Modification of rating mark

Change of rated current acc. to UL 60320

1681 Appliance Inlet					0118.2196	
creation date	created by	release date	released by	notification no.	revision	page
2014-01-06	helbljio	2014-02-11	hotzar	25633	-	1 of 2

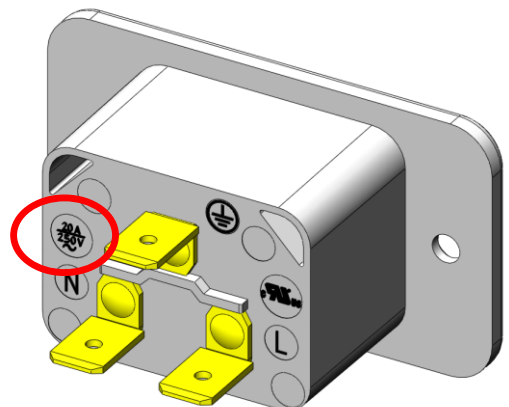
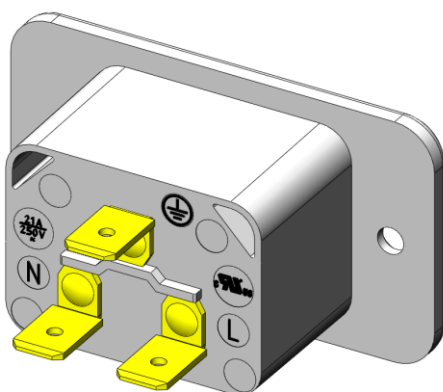
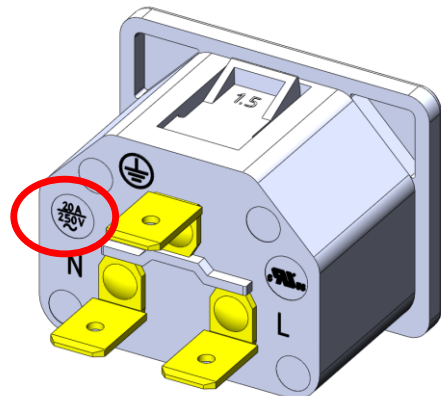
Old marking

New marking

Rated current adjusted to UL 60320
